**West Lacy (Fitchrona Rd to Seminole Highway)  
City of Fitchburg, WI**

**Advisory Group Meeting #1 Notes  
Wednesday 3-31-2021**

## Pro and Cons of Cross-section elements

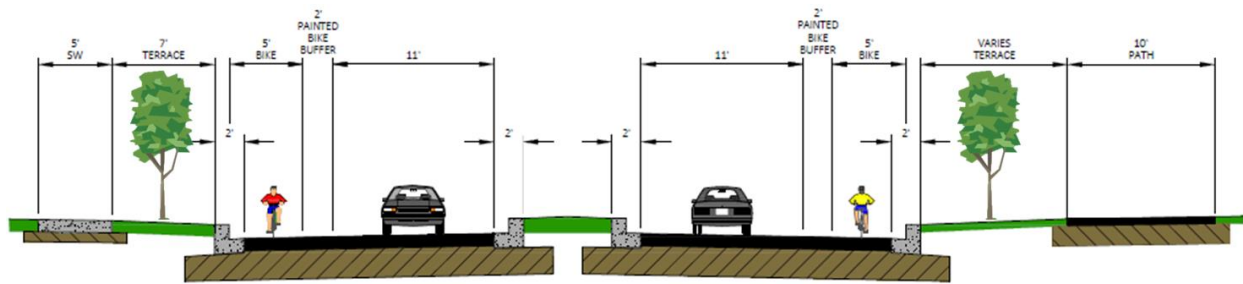
### Pros of Terrace

- Buffer between users
- Space for street trees and lighting
- Provides storage for snow
- Can account for grade changes

### Cons of Terrace

- Cost construction
- Cost maintenance
- Increased cross-section width

### Pros of Median

- Channelizes traffic
- Slows some drivers
- Provides pedestrian refuge
- Can account for grade changes

### Cons of Median

- Cost - \$575,000
- Increased maintenance
- Some increased runoff
- Requires 20' clear zone
- Increased roadway width

### Pros of buffered bike lane

- Separates different users
- On-street bike facilities are consistent with the rest of Lacy
- Flexible space for delivery and road work

### Cons of buffered bike lane

- Cost - \$500,000
- Increased pavement and runoff
- Loss of additional trees

### Pros of shared use path

- Provides high comfort facility
- Simple trail connections

### Cons of shared use path

- Cost
- Increased pavement and runoff
- Loss of additional trees

### Pros of sidewalk

- Separates different users
- Provides continuity and access to future development south of Lacy

### Cons of sidewalk

- Cost - \$150,000
- Unclear snow removal responsibility
- Unclear near-term usage

- Grading for S. Side Sidewalk
  - Grading the terrace and future sidewalk area will provide a clear zone for errant vehicles and reduce future regrading if development occurs. This area could be planted with native seed.
- 28' roadway – 26' asphalt surface, 24" Curb and gutter
  - 11' travel lanes and 3' unstriped shoulder area adjacent to both curbs was assume to provide space for stopped or mail delivery vehicles.
- Spot 75' medians at Rock Ridge Rd., the quarry entrance, and Commerce Park Dr.
- 7' terrace on north side of street
- North side 10' wide shared use path generally, expanding to 12' for approximately 1,900' along the hill centered on Commerce Park Dr.
